Departure from Design Standards CMFI Tabernacle of Praise

DDS-681

REQUEST	STAFF RECOMMENDATION
A 13-foot departure from the design standards to reduce the width of the driveway from 22 feet to 9 feet.	APPROVAL with conditions

STAFF REPORT

LANDSCAPE PLAN

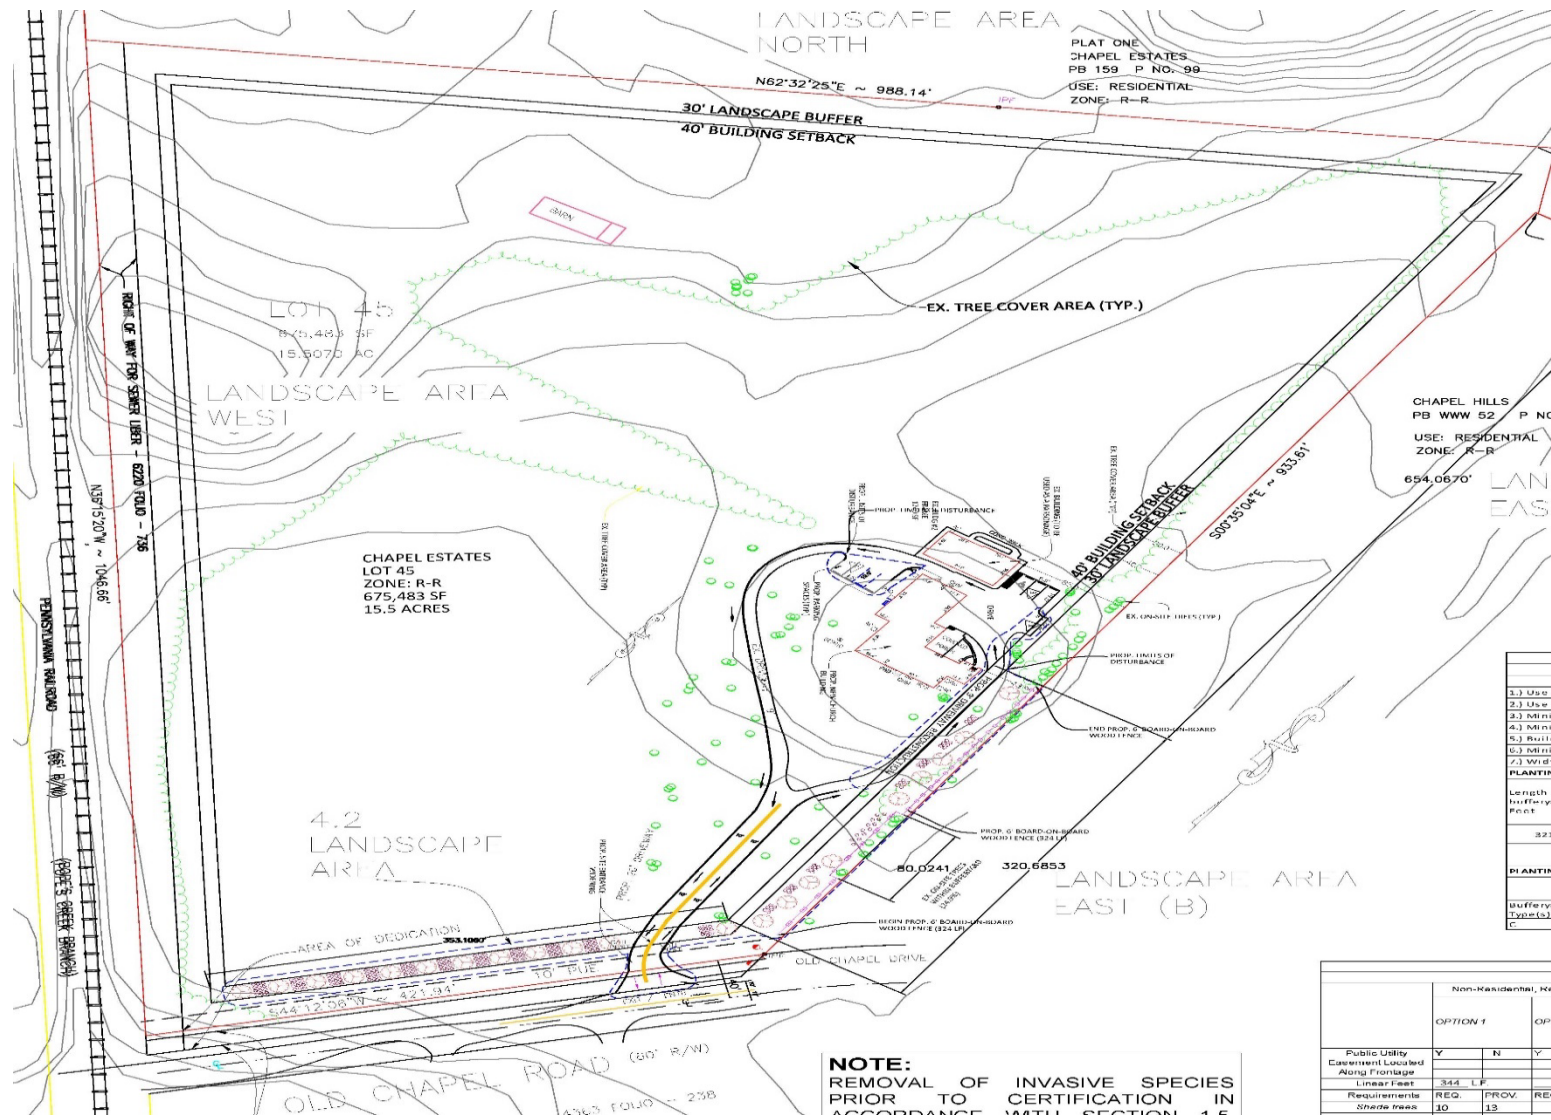
The Landscape Manual designates a place of worship as a compatible, medium-impact use with moderate effects on adjacent properties. Such a designation requires a Type C bufferyard to mitigate the impacts of the proposed use. A Type C bufferyard requires a minimum building setback of 40 feet, minimum landscape yard of 30 feet, and 120 plant units per 100 linear feet of property line. The submitted landscape plan complies with the stated requirements. The applicant also proposes 324 feet of 6-foot-high board fencing to provide more visual buffering of the uses.

Staff find that the combination of existing trees, landscape plantings, and fencing will adequately buffer the site, mitigating the medium-impact place of worship use.

The revised Landscape Plan was submitted on March 6, 2023 showing conformance to the Landscape Manual requirement and to the Tree Canopy Coverage requirements. Urban Design has no objection to the approval of this application.

EXHIBIT 1 – VEHICLE TURNING PLAN

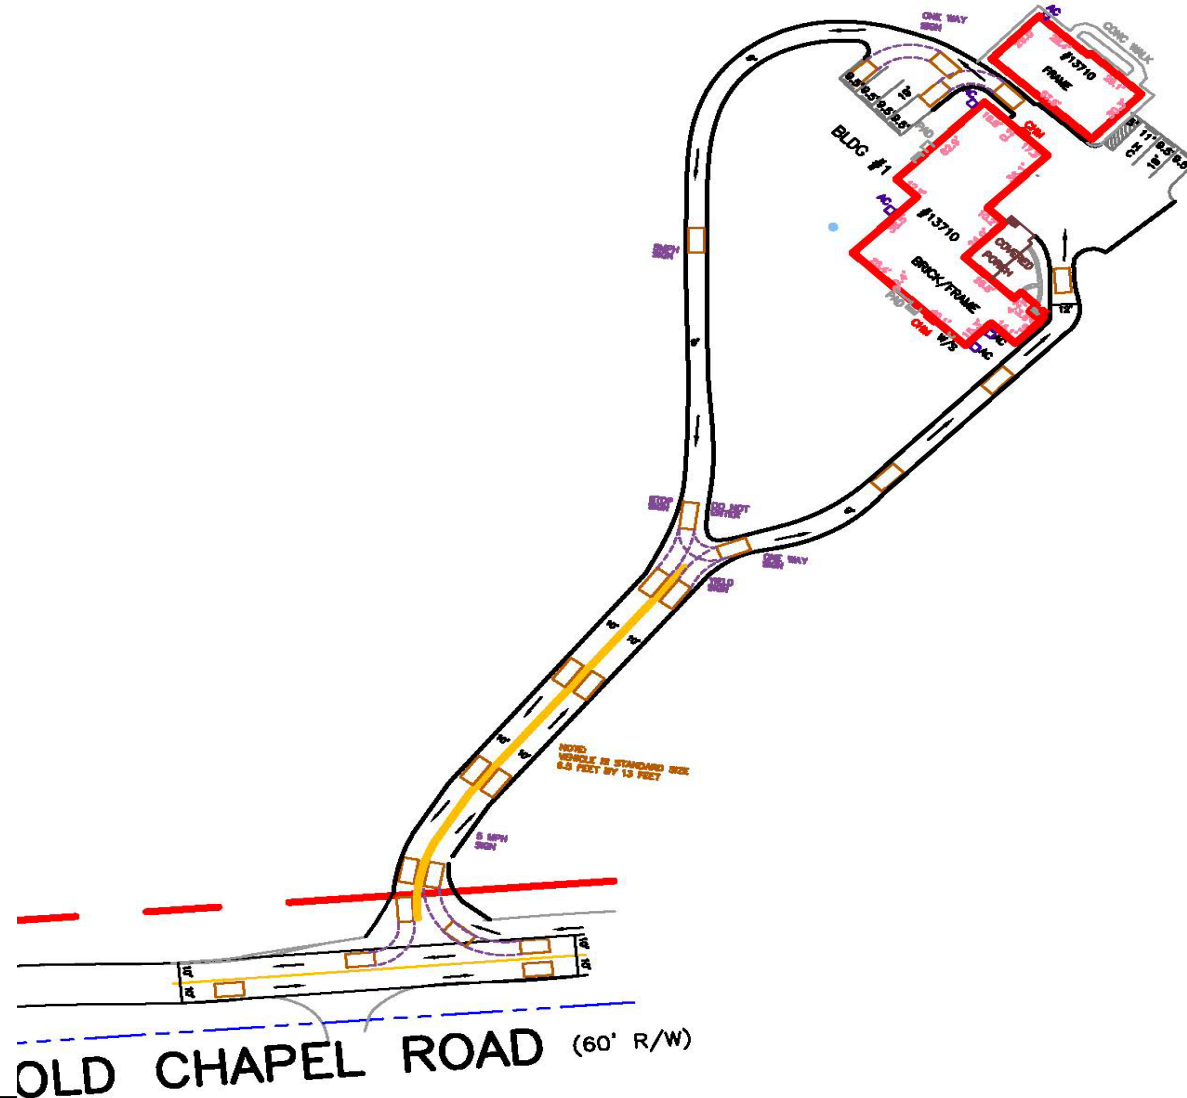
Staff reviewed the submitted vehicle turning plan, which resulted in modifications to the site that included a larger area of pavement to the west of the building. The large pavement area is necessary to facilitate the required radius for vehicles to safely access the parking spaces as well as additional paving on the two-way portion of the driveway which, in total, is approximately 20 feet wide. Given the modifications to the plans, staff believe that the parking spaces will be able to function as their intended purpose and will allow for safe maneuvers to the parking provided.

As shown on the plan and mentioned above, the proposed entrance driveway is approximately 20 feet wide. The vehicle turning plan displays the typical design vehicle classification for the site and demonstrates that 20 feet would provide the minimum distance required for two vehicles to safely pass, while entering or exiting the site. The vehicle size used for the vehicle turning plan is 6.5 feet wide, which would be the standard width of a passenger vehicle that would be accessing the site for its intended use as a place of worship.

The vehicle turning plan also shows the proposed signage throughout the site. There will be a 5 mile per hour (mph) sign near the driveway entrance. The 9-foot-wide driveway loop will contain a yield sign, one-way signs, a 5 mph sign, a stop sign, and a do not enter sign to facilitate traffic. The applicant will also provide a 6-foot wooden fence along a portion of the eastern property boundary.

Staff reviewed the vehicle turning plan which resulted in modifications to the site that included a larger area of pavement to the west of the building to facilitate the required radius for vehicles to safely access the parking spaces as well as additional paving on the two-way portion of the driveway which in total is approximately 20 feet wide. Given the modifications to the plans staff believes that the parking spaces will be able to function as their intended purpose and will allow for safe maneuvers to the parking provided.

Section 27-563 requires that a driveway connecting a street to a parking lot be at least 11 feet wide for each travel lane and based on the configuration of the site the two-way portion of the driveway would require a width of 22 feet. As shown on the plan and mentioned above, the proposed driveway is approximately 20 feet wide. The vehicle turning plan displays the typical design vehicle classification for the site and demonstrates that 20 feet would provide the minimum required for
